OFFICE OF  
**FRESNO**  
**IRRIGATION DISTRICT**

May 17, 2012

RE: Review of High Speed Rail 15% Plans for Segment 1B (Stanislaus to Santa Clara streets) and 15% Plans for Segment 1C (Santa Clara Street to South of American Avenue)

FID Facilities: Braly No. 14, Fresno Colony No. 24, North Central No. 26, Central No. 23, Viau No. 25, and Storey No. 237

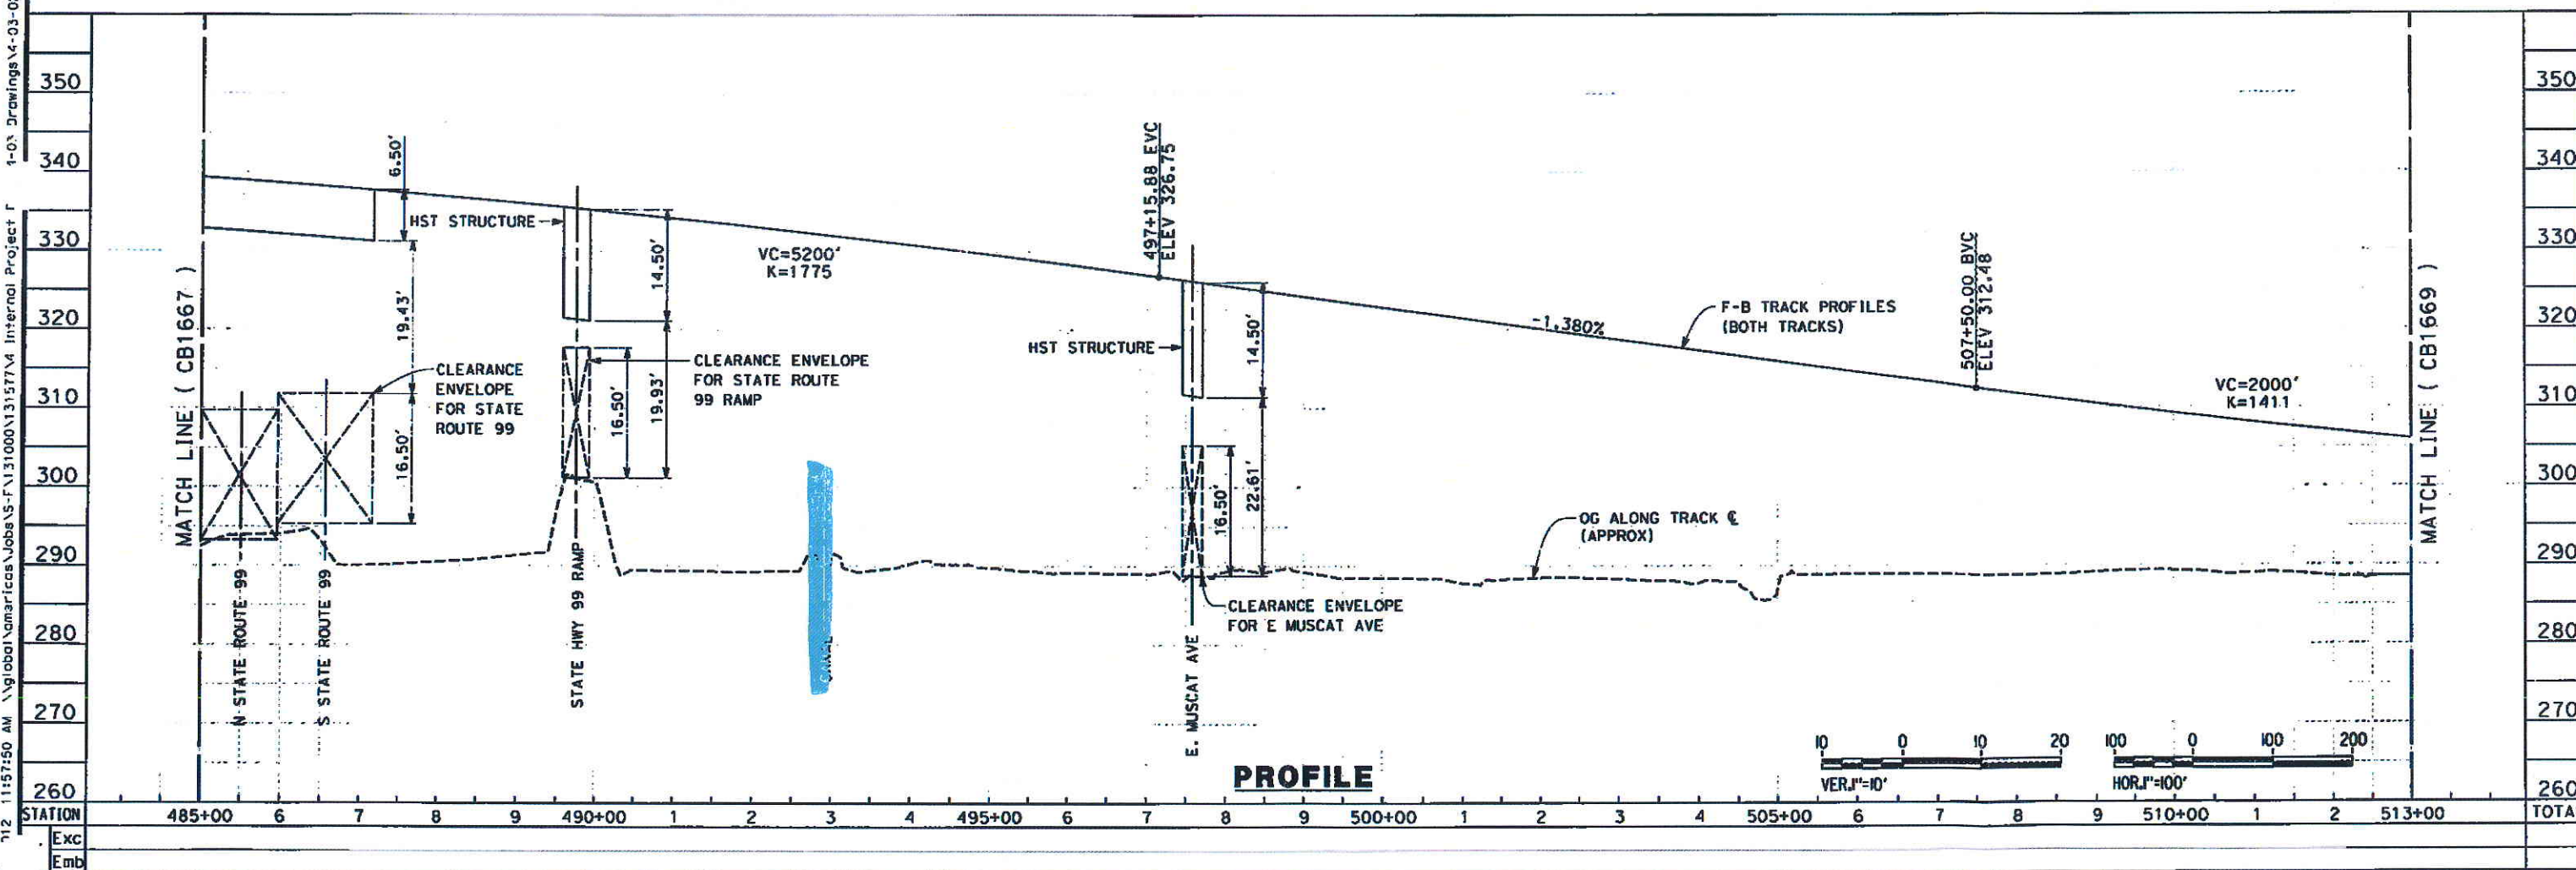
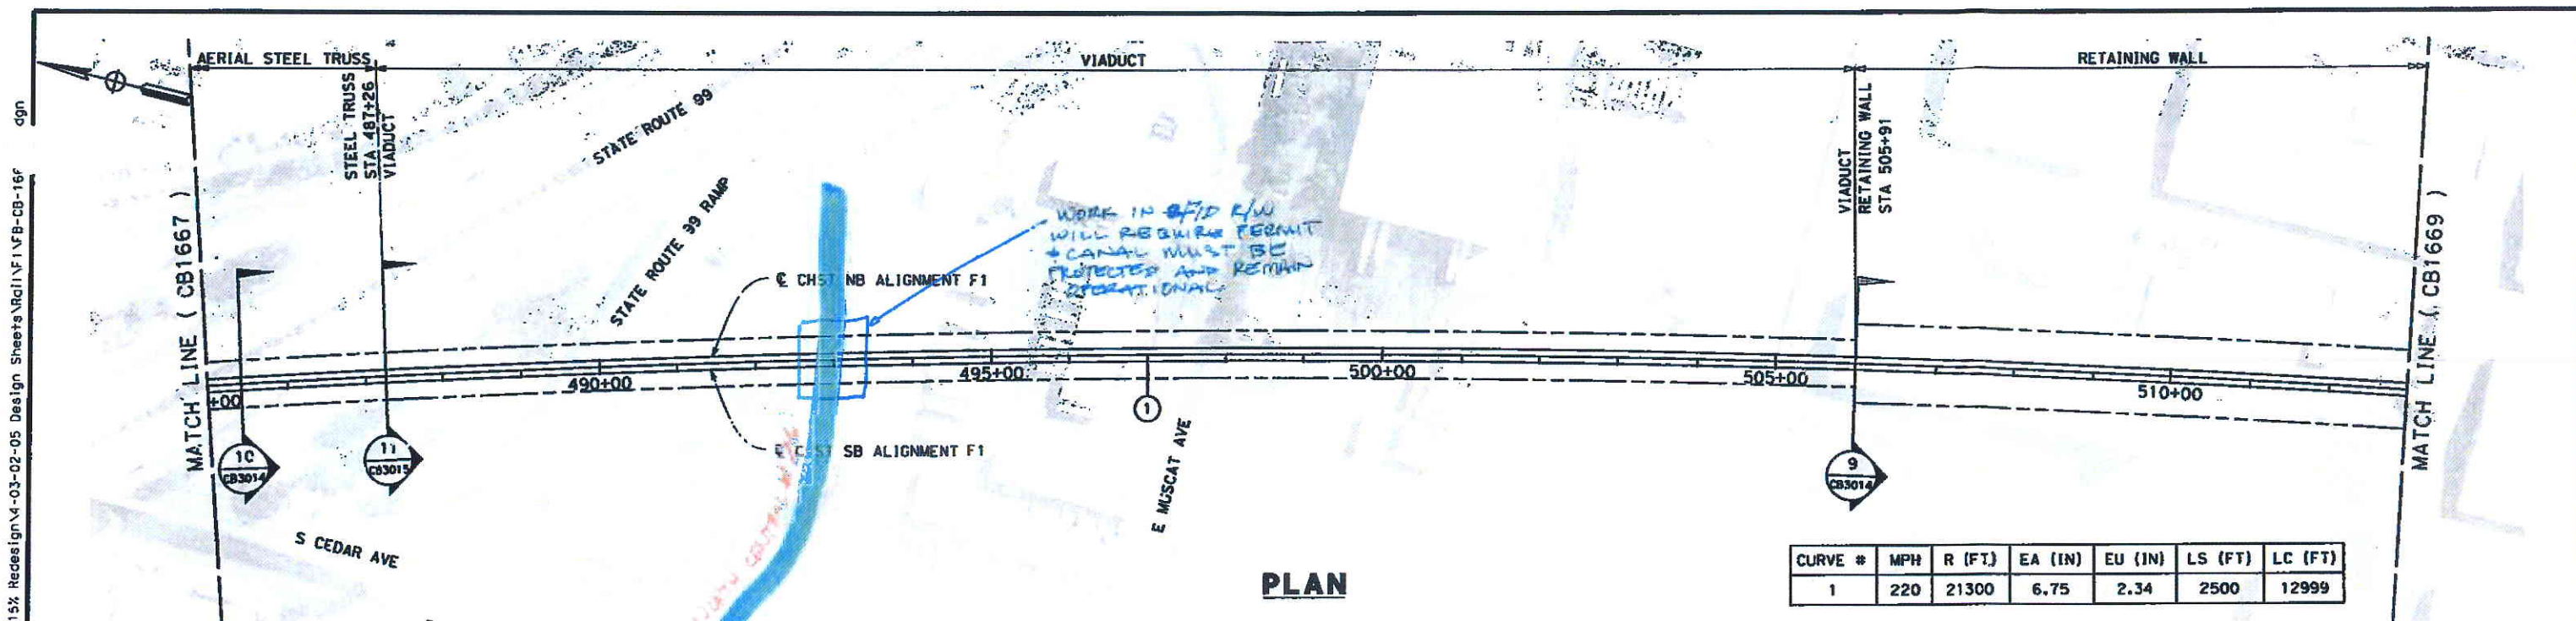
- It appears that the columns and footings clear the FID facility completely and the grade separation above the existing canal will allow for the open canal to remain, and that there will be no fencing limiting access to the canal crossing the HSR ROW. Please provide details if any part of a column or footing encroaches into FID's right of way, and show the existing canal right of way on the appropriate plan sheets. A clearance envelope for vehicular access along the canal bank shall be indicated on the plans for the North Central if the intent is to not box culvert the canal. If there is not adequate vertical clearance, an adequate turnaround area shall be provided. The existing open canal will need to remain in full operation during any construction activities occurring within FID's irrigation season. Any construction work within the existing canal right of way will require a permit from FID.

- Label the name of the facility to all appropriate plan sheets.
- Plan sheets reviewed include CB1668, SV2206. Please identify any other sheets that cover the area of this FID facility.

- For further clarification, attached are plan sheet markups on key sheets.

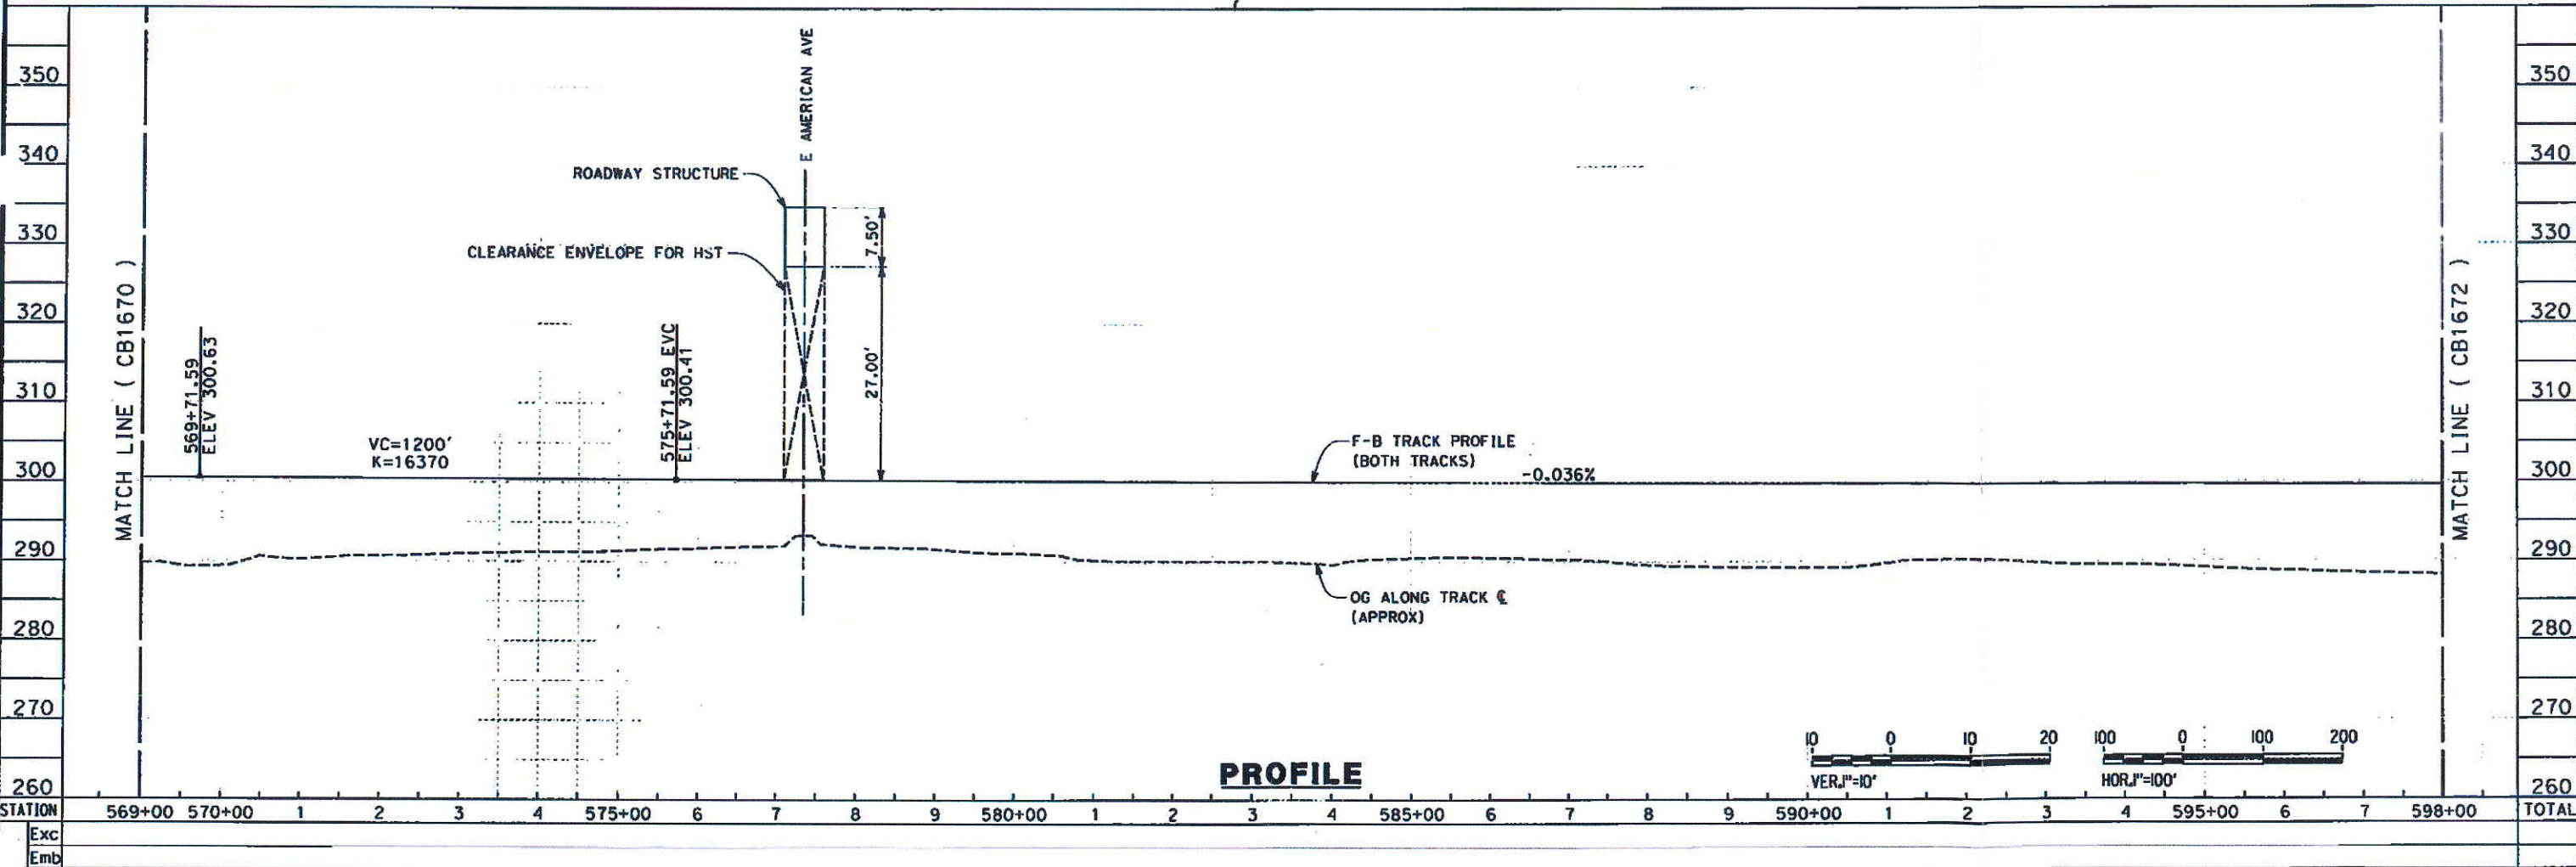
- Provide a plan/profile along the centerline of FID's facility, and include locations of other utility crossings in plan and profile views.
- The existing pipeline shall be removed and replaced with new ASTM C-361 RGRCP. The existing pipe within the CHSRA's right of way is not suitable to remain in-place with heavy equipment operating over it. The additional loading and vibration that the existing pipeline will experience will compromise the pipe. Protection of pipe is not an acceptable mitigation method. A 60-inch diameter access standpipe with galvanized steel bar grating metal cover shall be constructed on both sides of the right in conformance with FID requirements for urban setting.

- The new casing shall extend across the full right of way width. More detail is needed to understand the location of construction/receiving pits and the extent of construction to determine the work within the BNSF right of way. It is anticipated that the casing and new pipe will need to extend across the BNSF right of way as well, as a structure to connect to the existing pipe will be needed and is not desirable or accessible within railroad right of way.

- A 30-foot wide easement will be required for the new pipeline.
- Label the facility name and add the facility to all appropriate plan sheets. The Storey No. 237 is currently not reflected on any plan sheets.

- Plan sheets reviewed include CB1671, CT1028. Please identify any other sheets that cover the area of this FID facility.
- For further clarification, attached are plan sheet markups on key sheets, and a copy of available record plans of the Storey No. 237 at the CHSR crossing locations.
